Item ID: D212-664-201TRN

Item Name: Crosstube Turning Detail

DART AEROSPACE LTD	Work Order:	9988
Description: Crosstube Assembly (205/212 High Aft)	Part Number:	D212-664-241
Inspection Dwg: D212-664-241 Rev: D		Page 1 of 2

DRAWING NO. D212-664-241	TITLE CROSSTUBE ASSY (205/212 HI AFT)	REV. D	DART AEROSPACE LTD ENGINEERING ORDER		D.E.O. NO. D212-664-241-D-1	SHEET NO. SHEET 1 OF 2	SCALE NTS
DRAWN	CHECKED	MFG. APPR.	APPROVED	DE APPR.			
DATE 11.04.07	DATE 11.04.11	DATE 11.04.12	DATE 11/04/12	DATE 11.04.12

**D212-664-241/-241B
ASSEMBLY DETAIL**

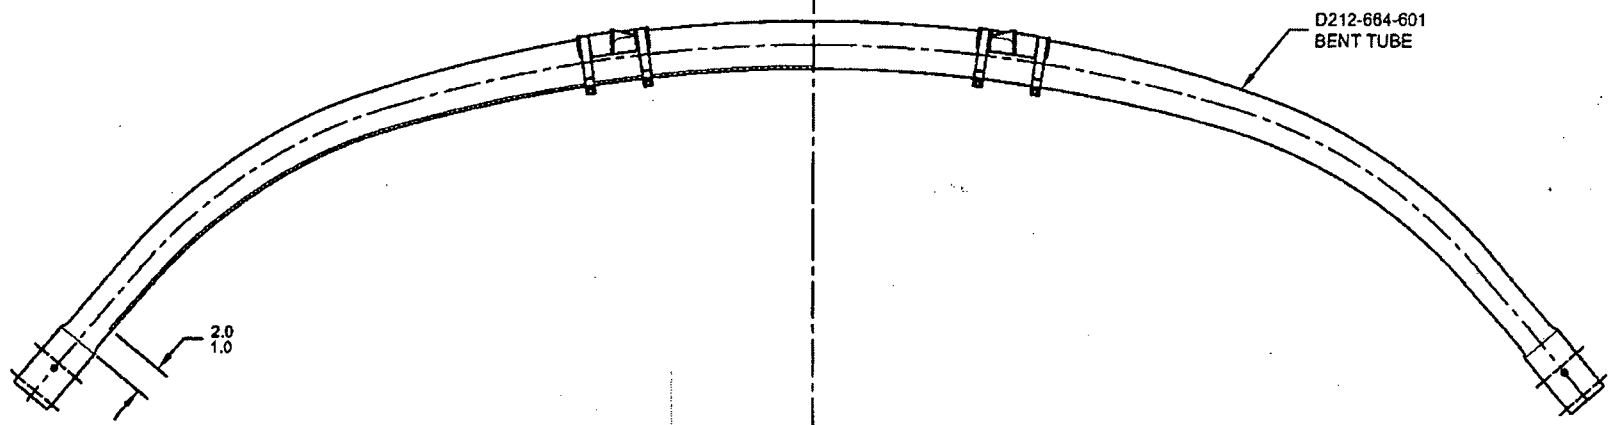
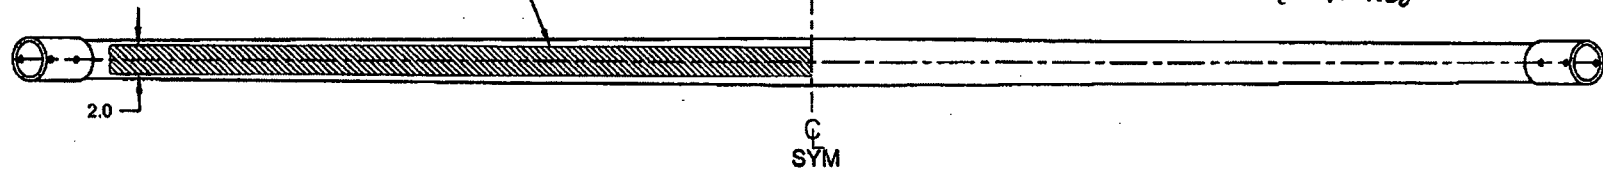
PURPOSE:

ADD AN INSPECTION WINDOW TO UNDERSIDE OF CROSSTUBE.

NOTES 2 OF SHEET 1 IS AMENDED AS FOLLOWS:

- 2) FINISH: CHEMICAL CONVERSION COAT PER DART QSI 005 4.1
PRIME INSIDE AND OUTSIDE PER DART QSI 005 4.2
MASK UNDERSIDE OF CROSSTUBE AS SHOWN (HATCHED AREA) AND
PAINT OUTSIDE PER DART QSI 005 4.2
REMOVE MASKING AND APPLY CLEAR COAT

- 2) FINISH: CHEMICAL CONVERSION COAT PER DART QSI 005 4.1
PRIME INSIDE AND OUTSIDE PER DART QSI 005 4.2
PAINT OUTSIDE PER DART QSI 005 4.2

MASK AREA PRIOR TO PAINTING,
REMOVE MASKING AFTER PAINT
AND APPLY CLEAR COAT
